DETONTI SQUARE SUBDIVISION, MAP THREE,
BLOCK 553, RESUBDIVISION OF LOT 12

APPLICATION NUMBER 10 DATE October 2, 2008

DETAIL SITE PLAN

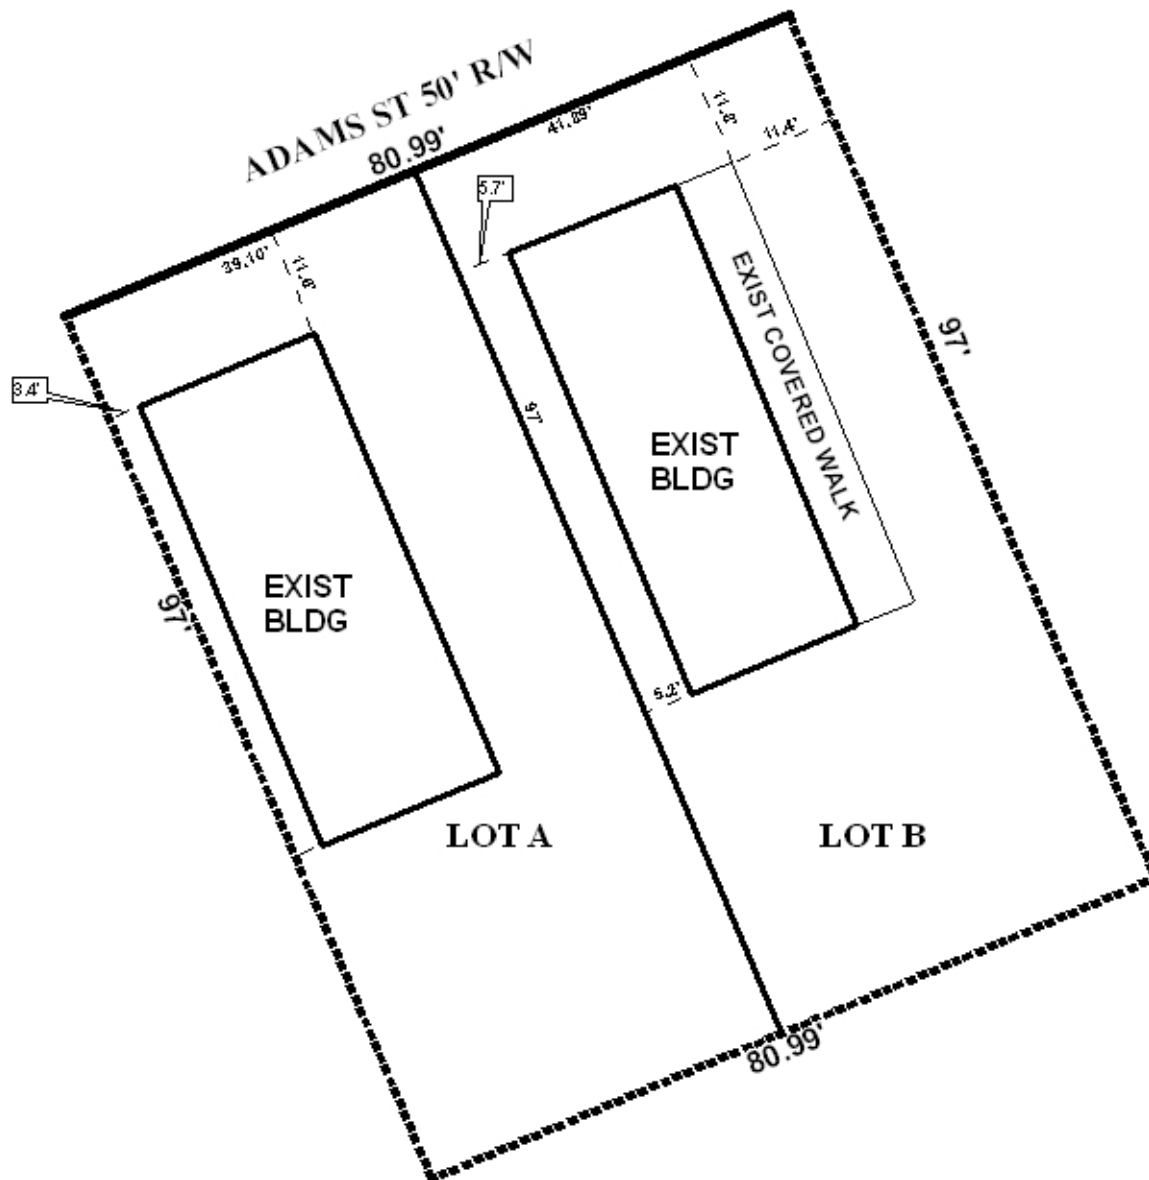
The proposed subdivision has frontage on Adams Street with a compliant 50' right-of-way; therefore, no dedication would be required. The plat does not illustrate the minimum front building setback line. Since the site is located within the De Tonti Square Historic District, the Historic District overlay setbacks would apply and a note should be required on the final plat stating such. As a means of access management, a note should be required on the final plat

limiting each lot to one curb cut to Adams Street, with the size, location, and design to be approved by Traffic Engineering and conform to AASHTO standards.

The lots are not labeled on the plat with their sizes; therefore, the plat should be revised to label each lot with its size in square feet, or a table should be provided furnishing the same information.

- 1) placement of a note on the Final Plat stating that the front minimum building setback line is governed by the Historic District overlay;
- 2) placement of a note on the Final Plat stating that each lot is limited to one curb cut to Adams Street, with the size, location, and design to be approved by Traffic Engineering and conform to AASHTO standards;

- 3) labeling of each lot with its size in square feet, or the provision of a table on the plat furnishing the same information;
- 4) placement of a note on the Final Plat stating that development of this site must be undertaken in compliance with all local, state and Federal regulations regarding endangered, threatened or otherwise protected species; and
